PEACEFUL RIDGE AT FOUNTAIN VALLEY SUBDIVISION

RESIDENTIAL SUBDIVISION CONSTRUCTION DRAWINGS

EPC STORMWATER REVIEW COMMENTS ARE SHOWN IN ORANGE BOXES WITH BLACK TEXT

PEACEFUL RIDGE AT FOUNTAIN VALLEY
MELTING SKY DRIVE
PLAN AND PROFILE
EL PASO COUNTY, COLORADO

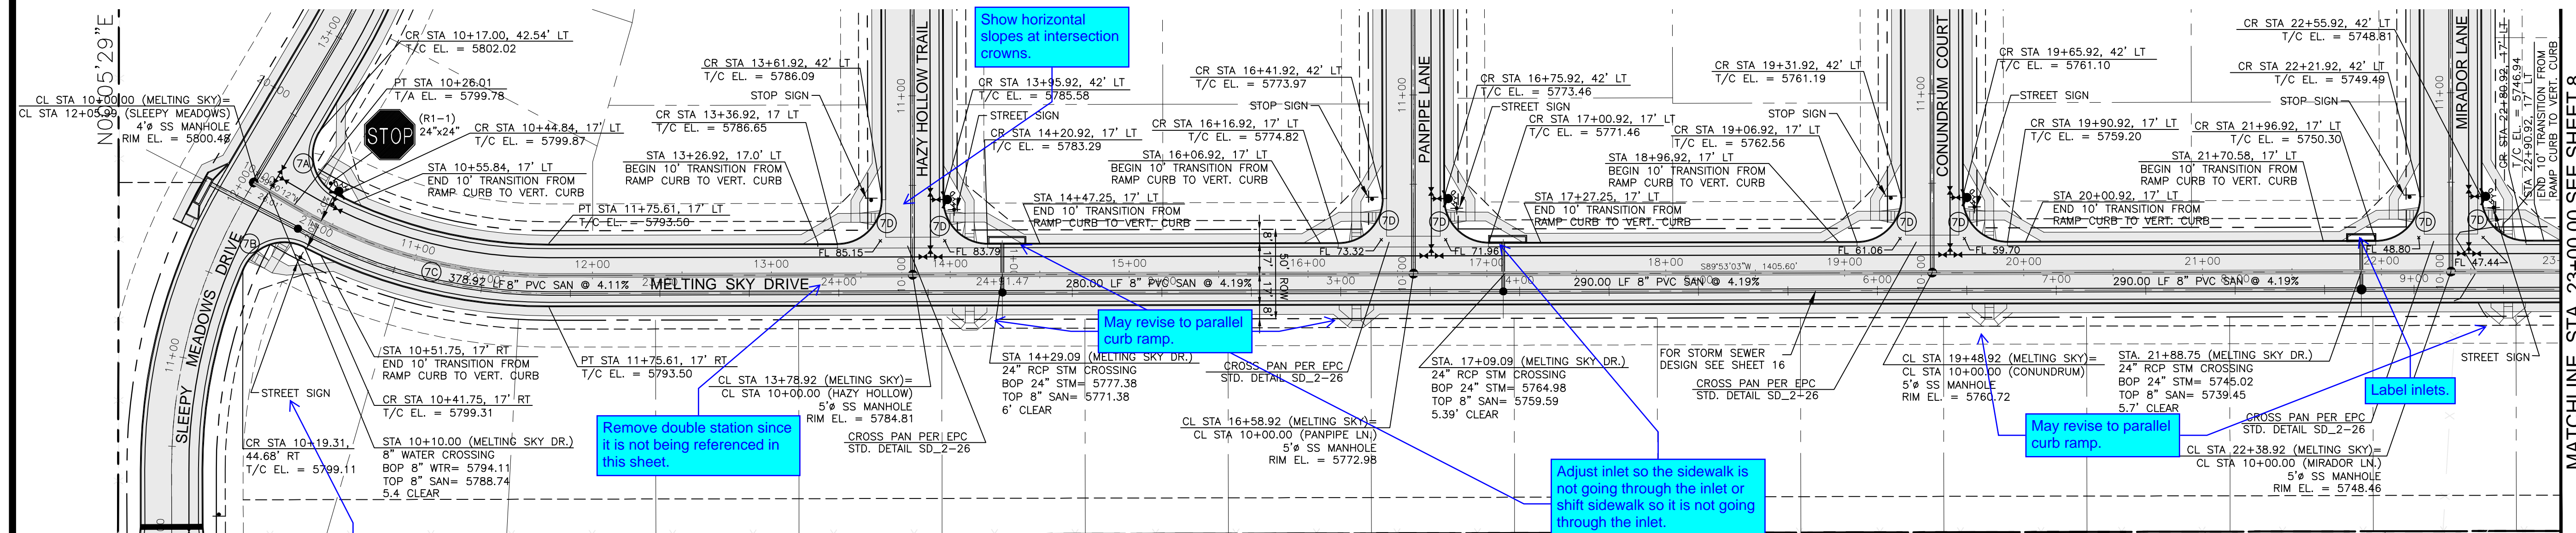
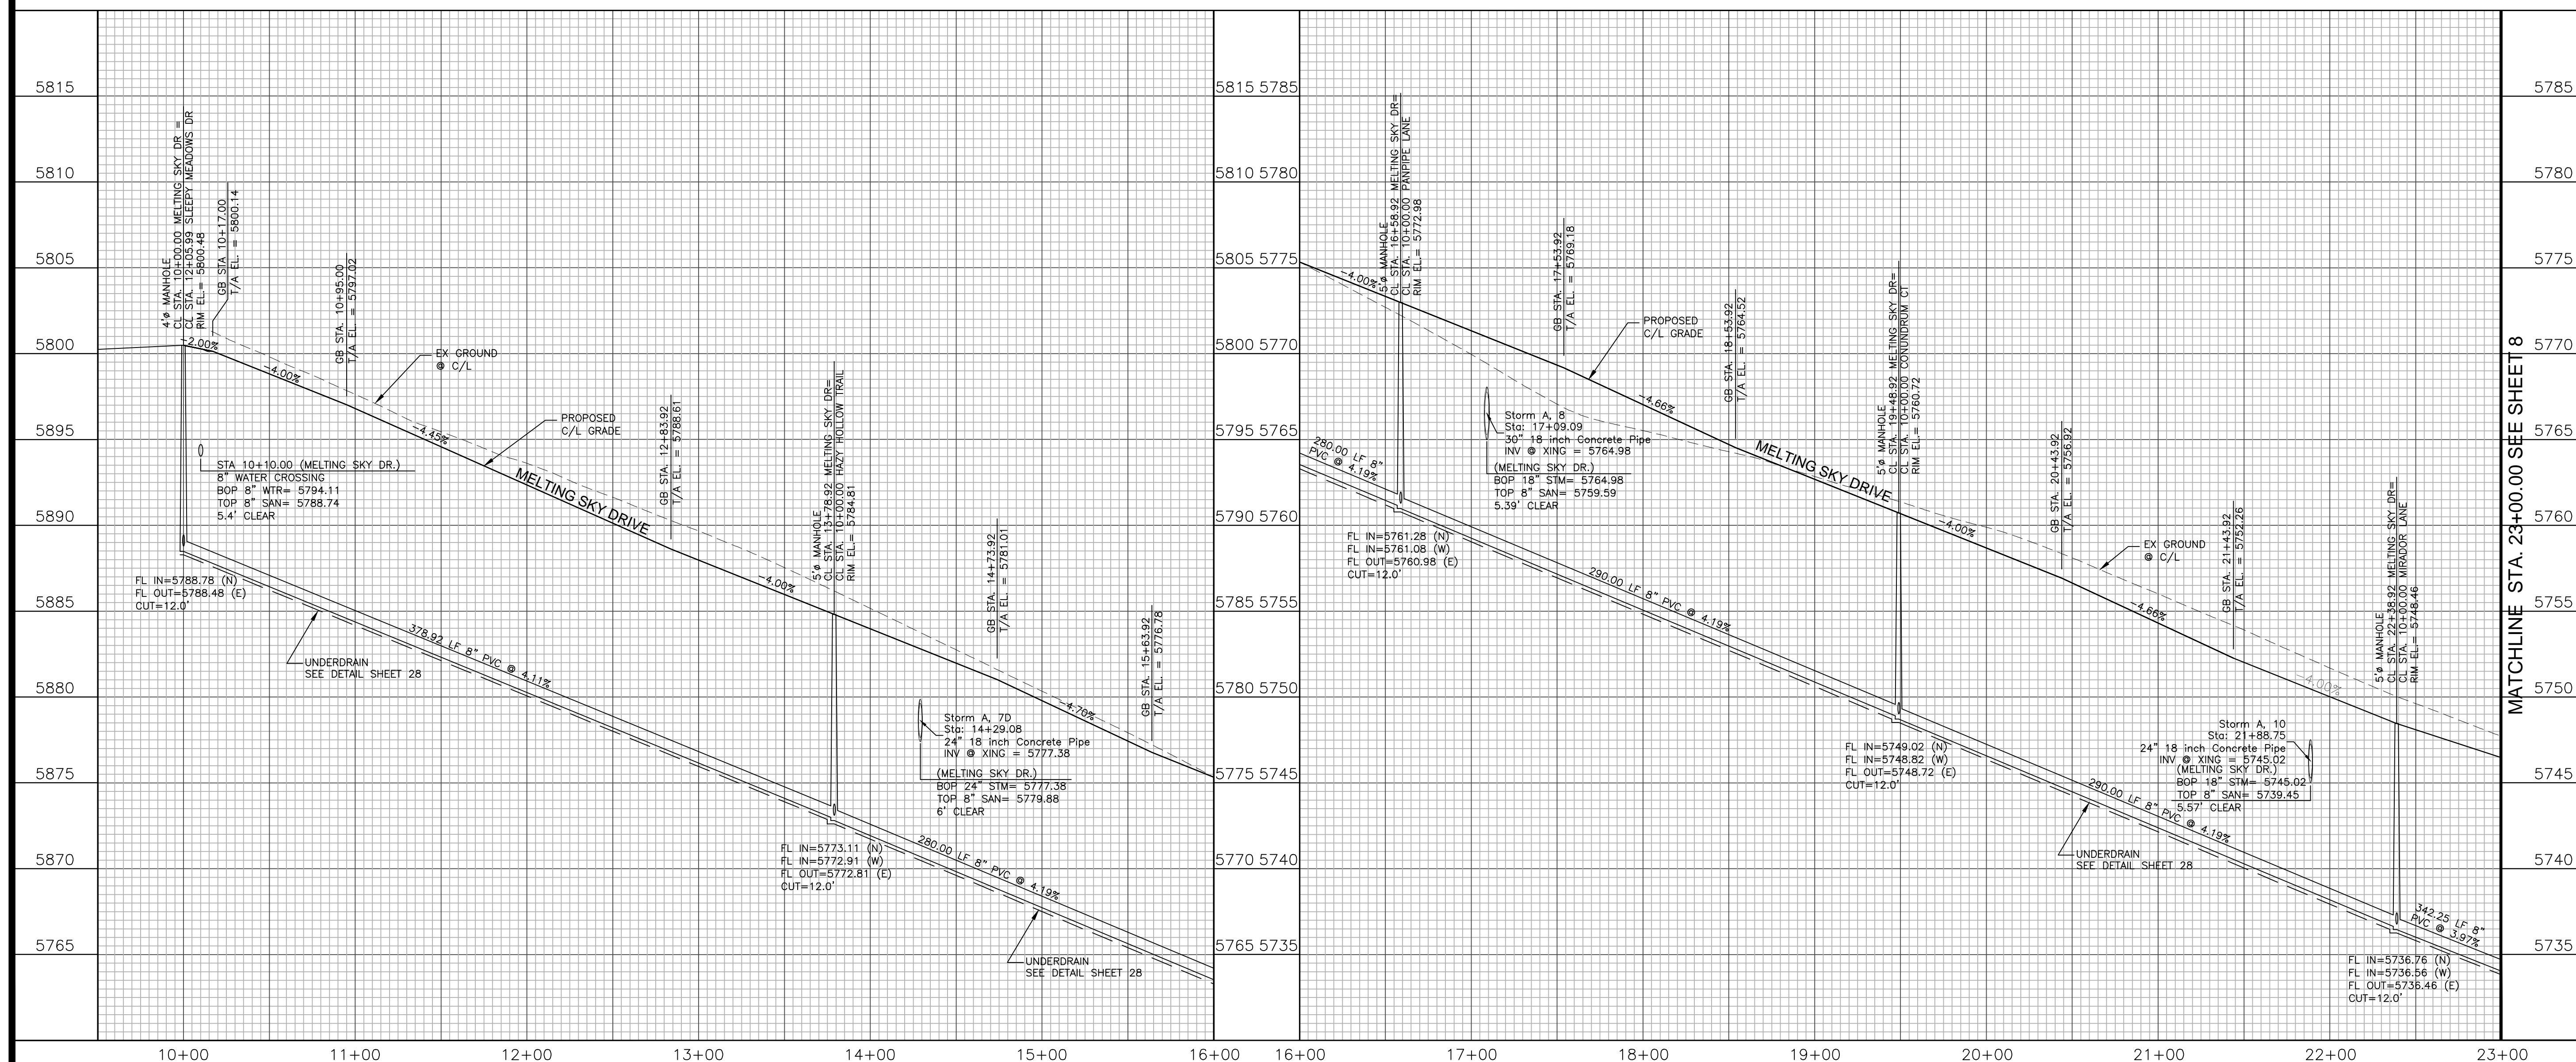
- Add matchlines to plan and profile
- Label lot numbers

5D and 5E are not shown in the legend. A deviation request is required for the knuckle design not meeting ECM criteria.

- Add matchlines to plan and profile
- Label lot numbers

PANPIPE LANE PLAN VIEW

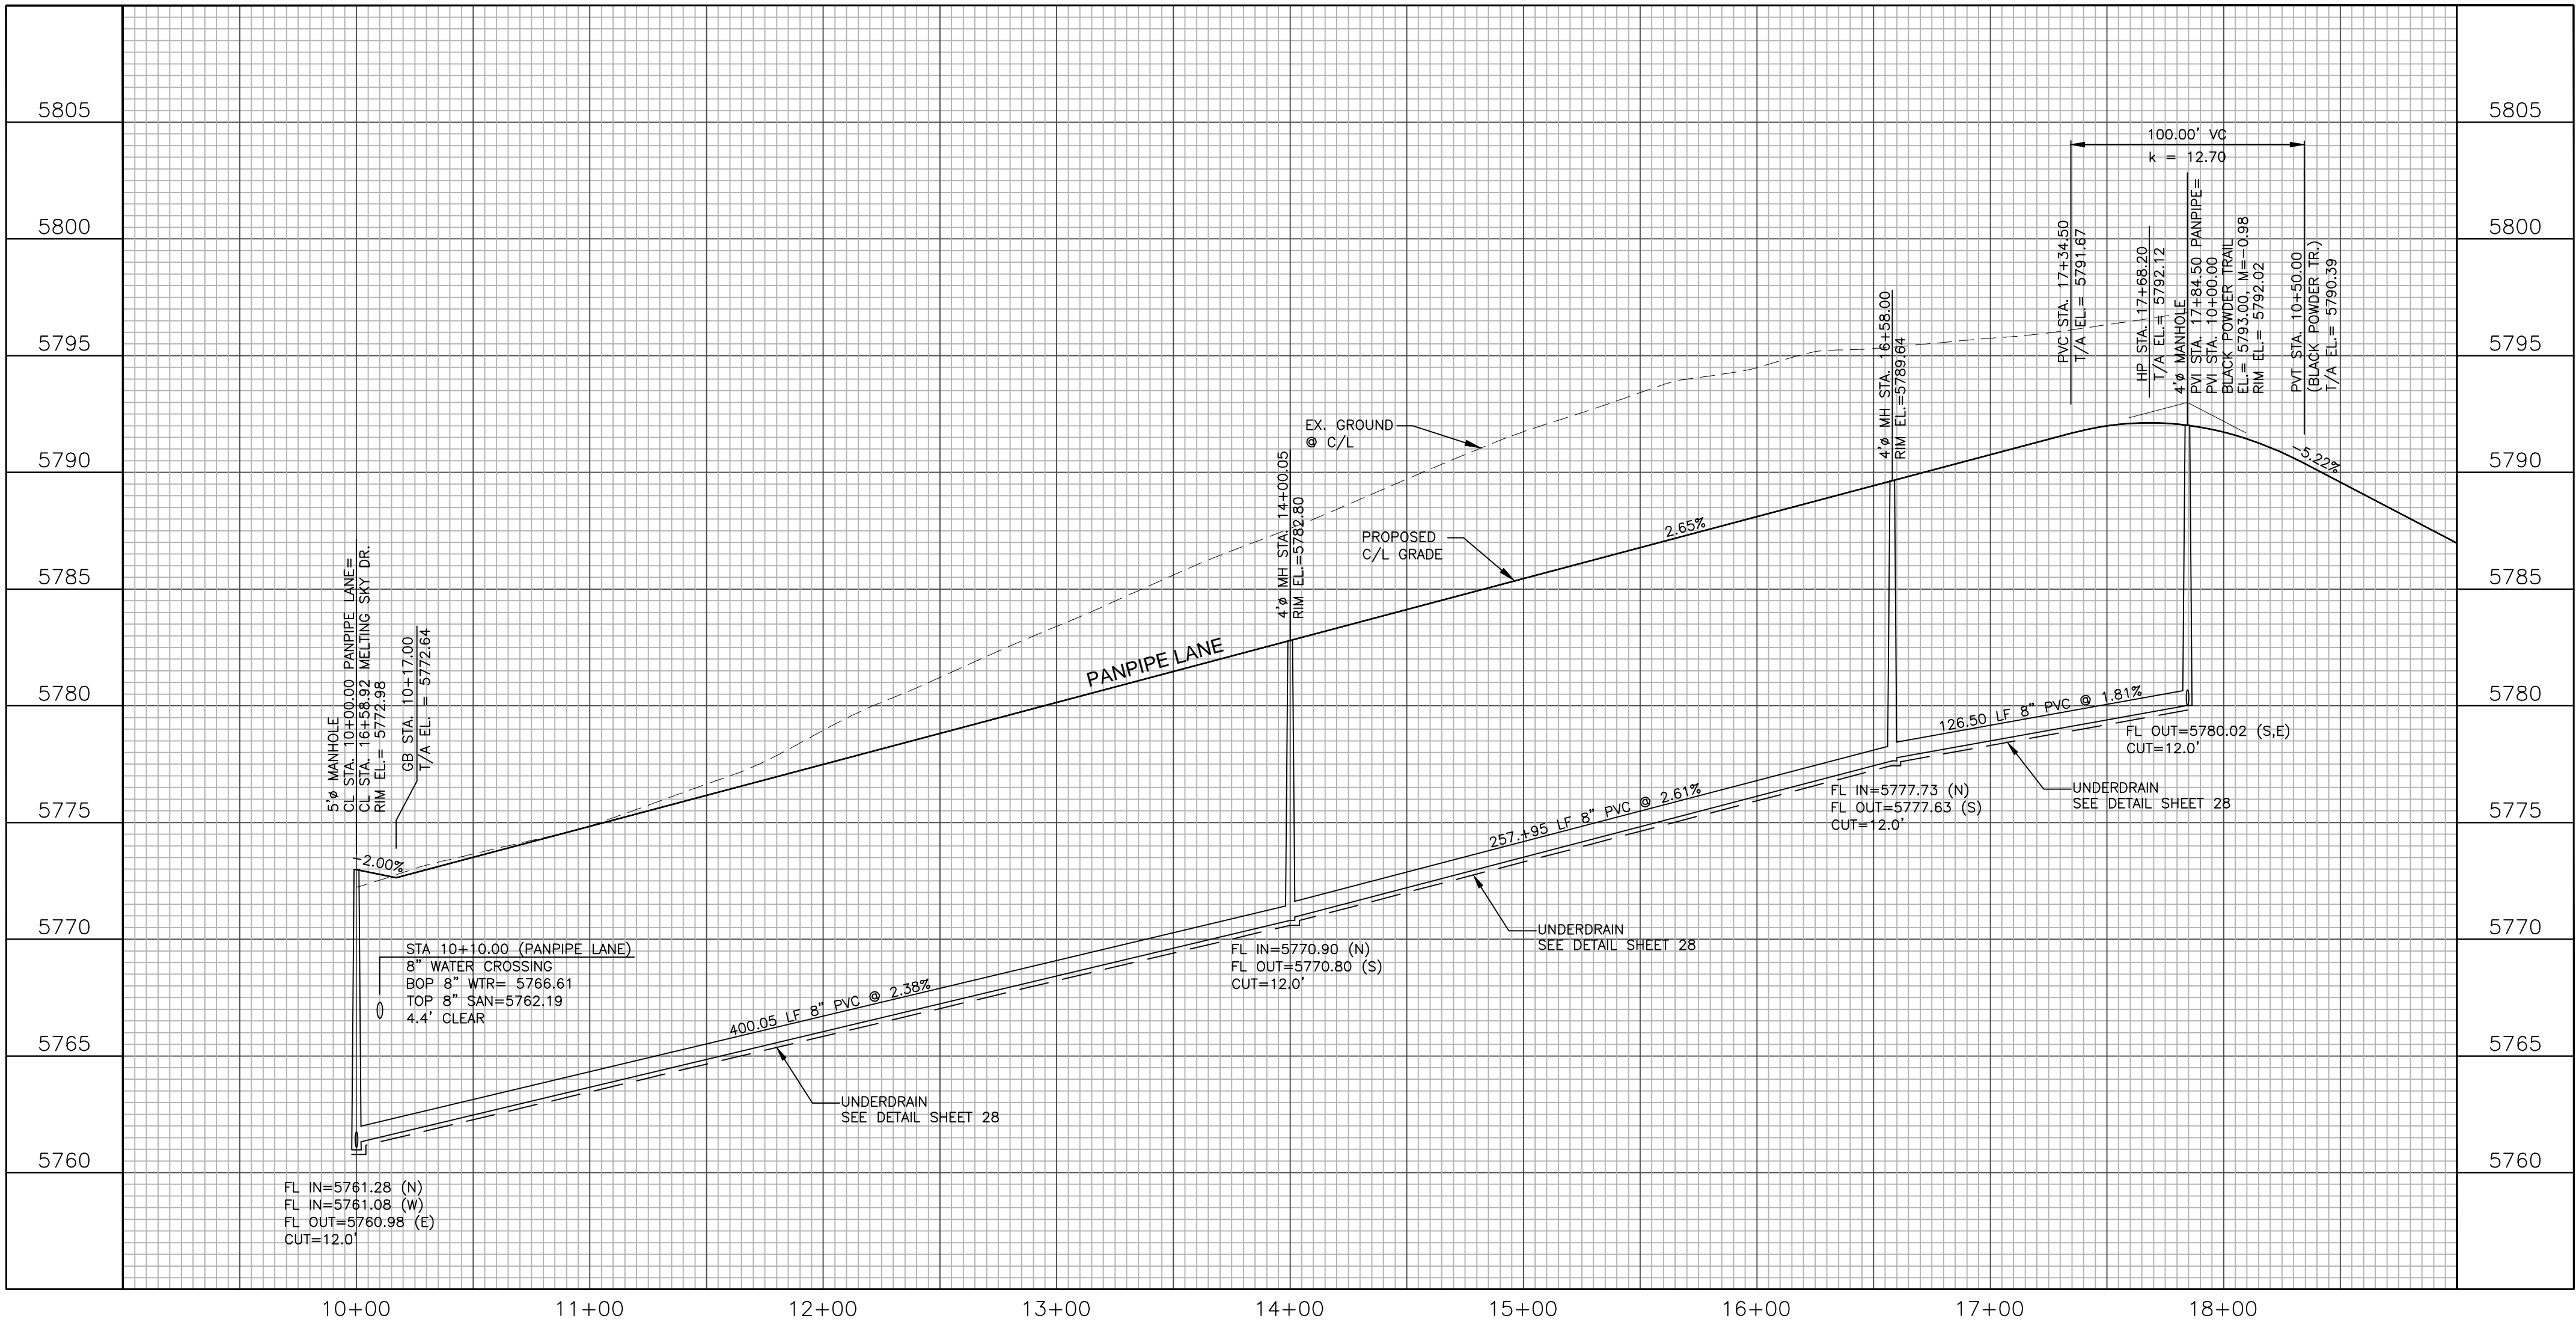
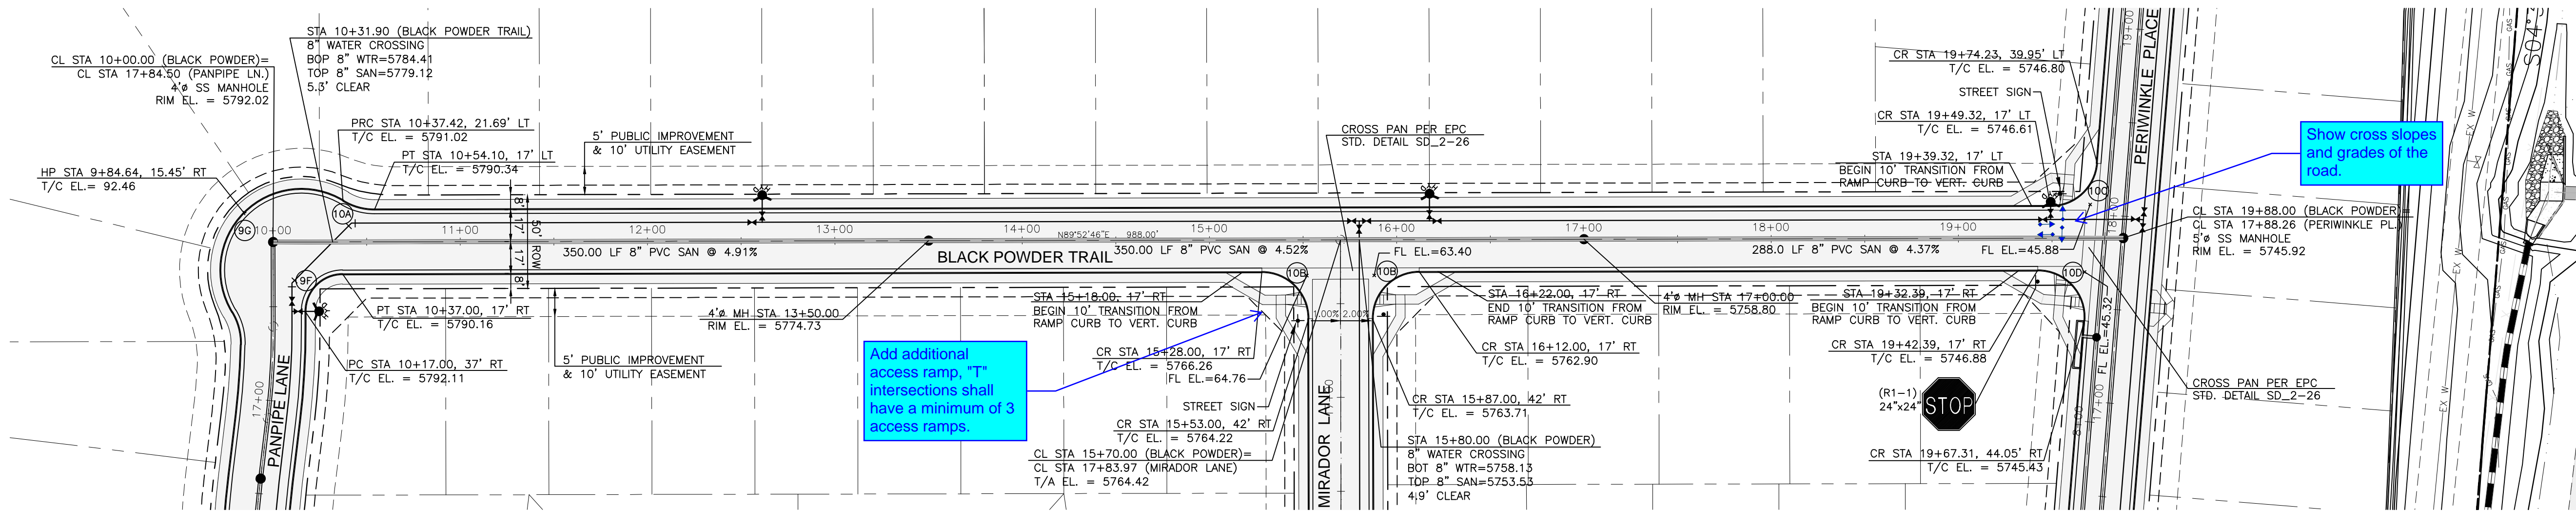
Add matchlines to profile and plan views.
Add road classification and speed limit.

Move all street sign names to the same post as
stop signs.
